KING'S MARK ENVIRONMENTAL REVIEW TEAM

DUNHAM POND PROPERTY

NEW FAIRFIELD,
CONNECTICUT

Environmental Review Team Report

Figure 2

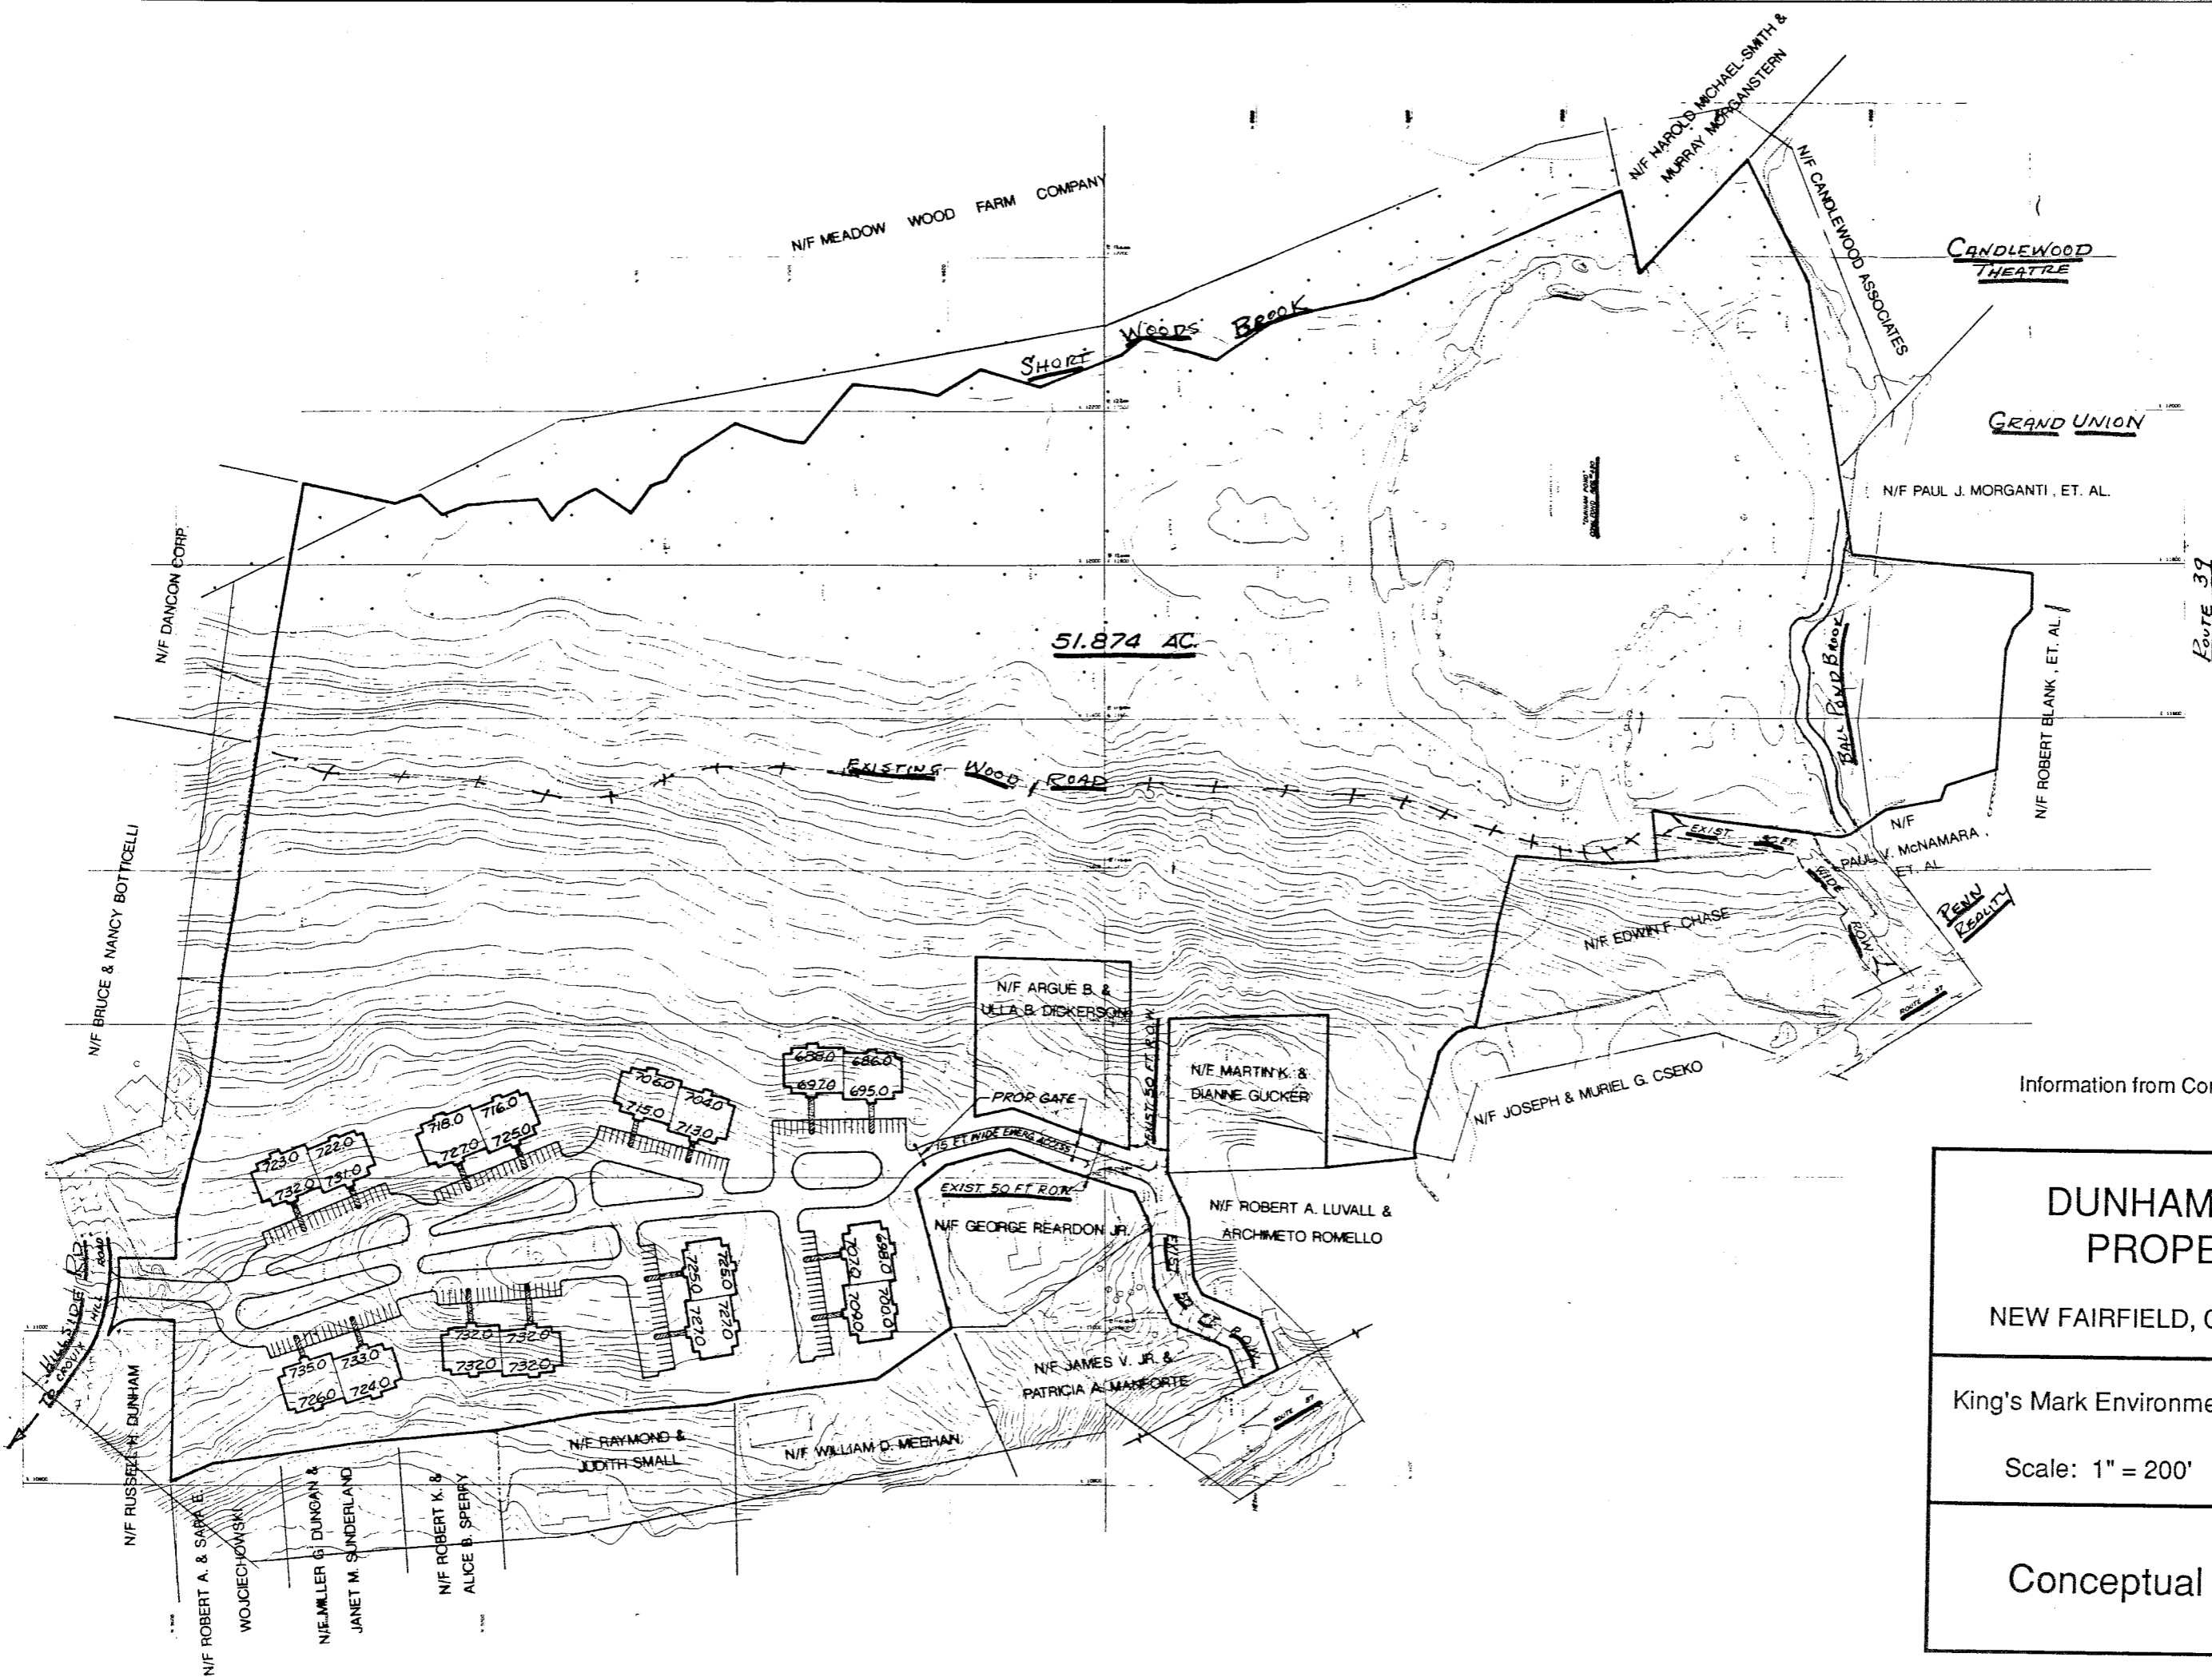
In this proposal, affordable housing is in the form of multi-family housing. The conceptual site plan locates 72 multi-family units around the top of the upland portion of the property. This upland portion is characterized as having slopes averaging approximately 11%. These slopes will require careful attention to erosion and stormwater runoff controls for any type of housing proposed for this area. The site plan indicates the proposed multi-family units will be developed adjacent to existing single-family detached housing with minimal distances for buffering. An increase to this minimum buffering should be considered.

several curves and changes in grade elevation which may affect its ability to be used as a public roadway. Additional access to the site from Hillside Drive has been indicated on the plans. This access point passes over property presently held by the spouse of the site's owner.

Access to the 72 multi-family housing units is proposed via Hillside Drive, connecting to Croix Hill Road, connecting to Route 37. This connection would increase the traffic volumes on the 2 Town roads. Based upon the Trip Generation manual of the Institute of Transportation Engineers, 72 elderly housing units, as proposed in the concept site plan, would generate daily traffic equal to that generated by approximately 24 single-family homes. The affected Town roads probably have adequate capacity to effectively handle the additional traffic. The point of connection from the site to Hillside Drive is on a curve on a hill. The sight lines at this proposed access are limited and should be examined by a qualified traffic engineer. Negotiations to expand the site's southern most right-of-way should receive priority because it has several advantages over the other points of access.

The Town is considering senior citizen housing for the site because of its proximity to the New Fairfield Center. The change in grade elevation from the commercial center of New Fairfield to the portion of the site proposed for elderly housing development represents a substantial hill for senior citizens to walk up, possibly negating a benefit of locating senior citizen housing on the upland portion of the site.

Because the lower portion of the site is close to the commercial and institutional services located within the Fairfield Town Center area, consideration should be given to locating a smaller number (20-30) of senior citizen housing units in this area of the

property (instead of the uplands area indicated on the concept site plan), just above the floodplain and wetlands. Access to this area of the site could be achieved over the existing lower right-of-way, if it could be widened to Town road standards. This would mitigate some of the problems of buffering and access associated with the housing development proposed on the concept site plan.

Figure 4

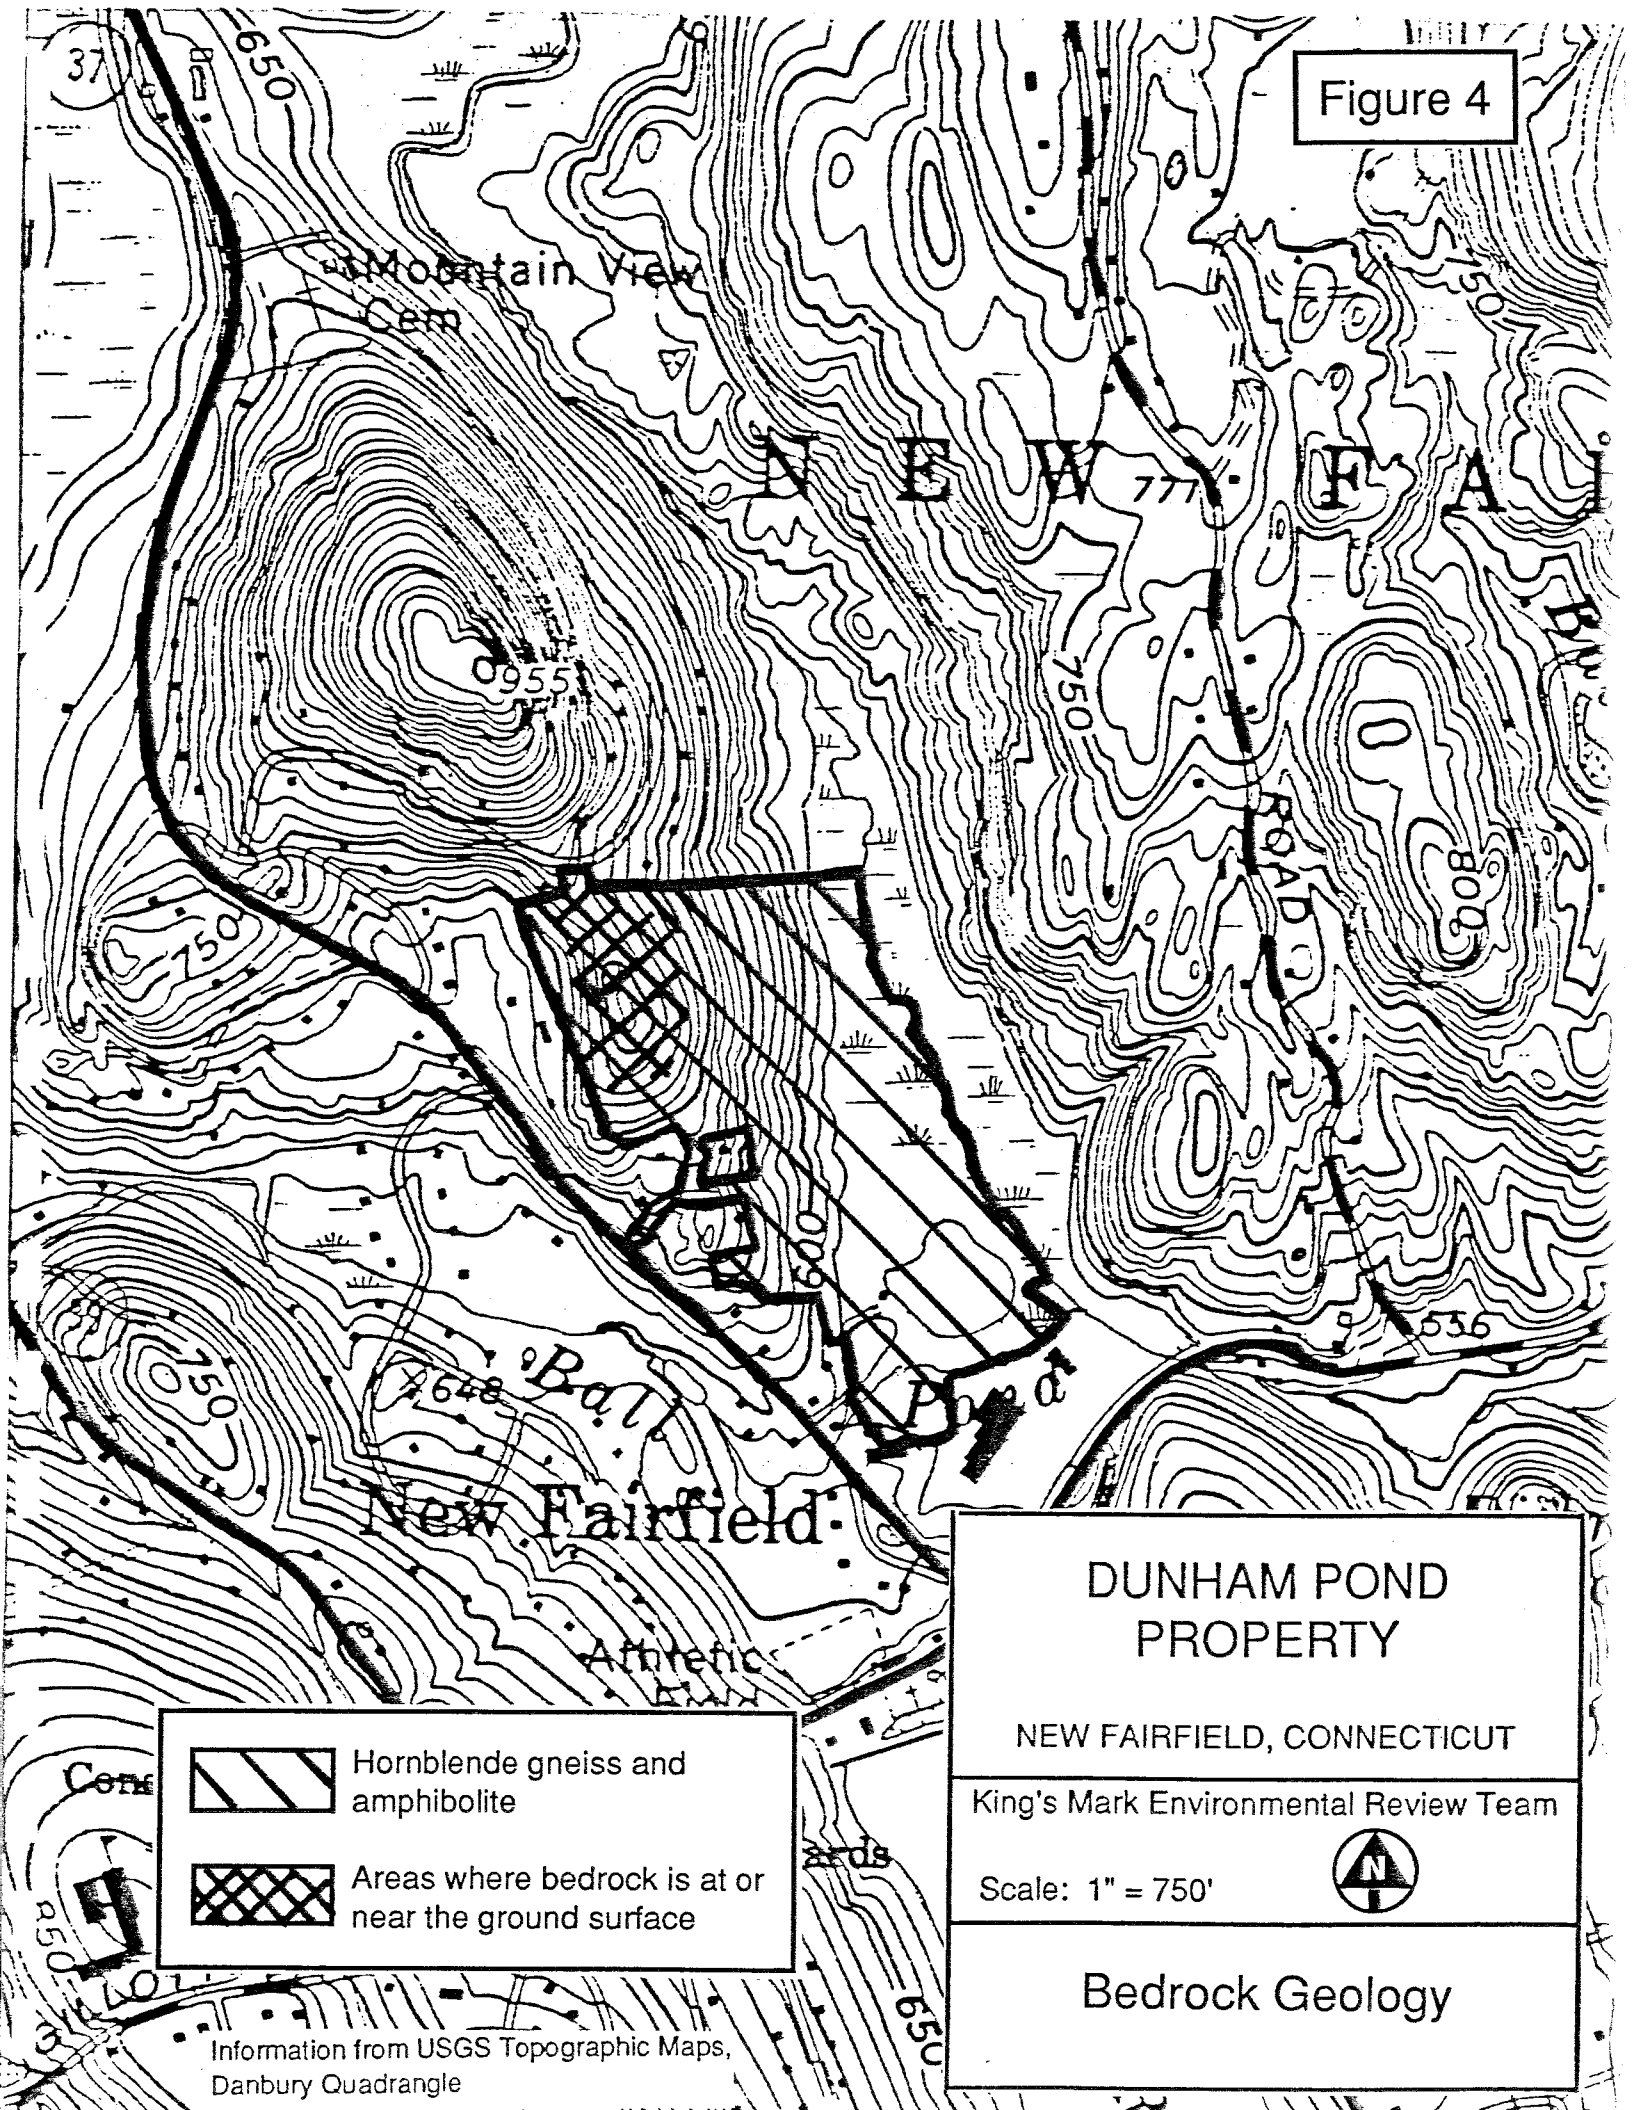
Bedrock is probably no more than 10 feet deep in most places on the site, but subsurface exploration is required for verification. The underlying bedrock appears to be the major aquifer for domestic water in the area. It may be a viable water supply source for the proposed affordable/elderly housing units, but testing is required (see Water Supply section).

Because residential buildings and roads are presently planned for the western limits and because bedrock exposures are widespread, the bedrock is the major constraint for development in this area. Blasting, which raises development and engineering costs, may be required in this area. Geotechnical studies should be conducted to determine the bedrock profile and the amount of blasting needed.
